25/60220 - PERMISSION for continued use of the existing quarry to the permitted depth of minus 5 mOD, including drill-ing, blasting, crushing, processing, stockpiling of materials, associated roads and ancillary services (granted under Planning Ref. File No.: 09/1958 and ABP Ref.: PL07.235821); Continued use of open storage areas; Continued use of existing permitted concrete manufacturing facility (granted under Planning Ref. File No. 09230 and 19/517: ABP-304769-19); Continued use of the existing office (granted under Planning Ref. File No.: 09/1958 and ABP Ref.: PL07.235821); Continued use of the existing maintenance shed (granted under Planning Ref. File No. 09610); Continued use of the existing water management system (including settlement lagoons), weighbridge and wheelwash; Lateral extension of the existing permitted quarry area over a previously permitted extraction area (granted under Planning Ref. File No. 06/4125) of c.4.6 ha. area to a final floor level of minus 5 mOD. The total quarry extraction area will be c. 13 Ha.; Restoration of the application area to natural habitat after uses following completion of ex-traction. The proposed development is within an overall appl

Figure 7.6 Groundwater Level Plots

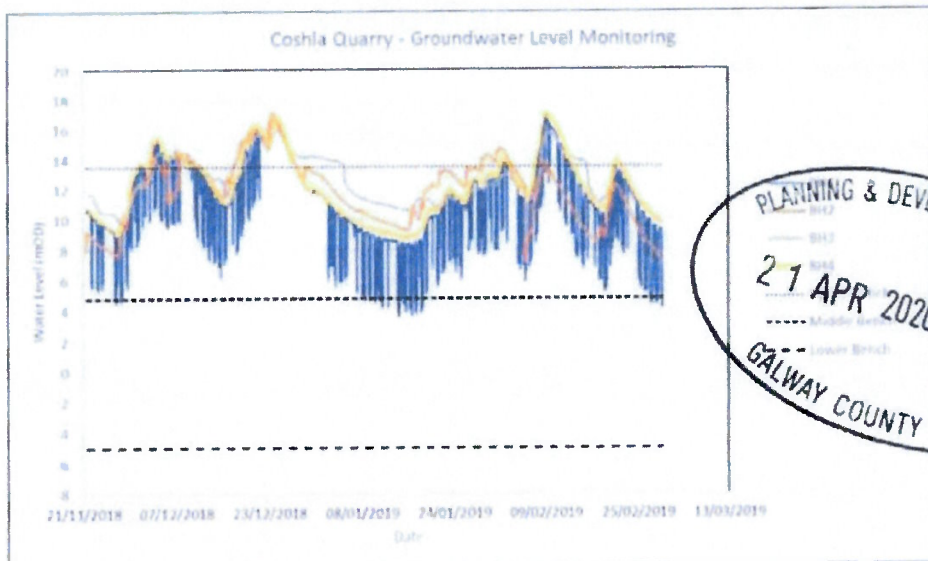
This planning application (Galway County Council 2560220) EIAR is in denial of the established fact that there are ground water table levels and that Coshla Quarries Limited wishes to continue to extract from the proposed development site to a level that is below the water table as confirmed by the Hydrologists hereunder.

A Hydrology Report (2020) carried out by MKO Environmental Consultants also confirmed the existence of the water table at paragraph 7.4.3.1 – *“Impacts on Local Groundwater Levels: The current quarry and the proposed expansion area exist below the groundwater table (refer to Figure 7.6 above). As with the existing quarry, dewatering will be required to maintain the floor of the proposed expansion area dry. This has the potential to further impact on local groundwater levels away from the site.”*
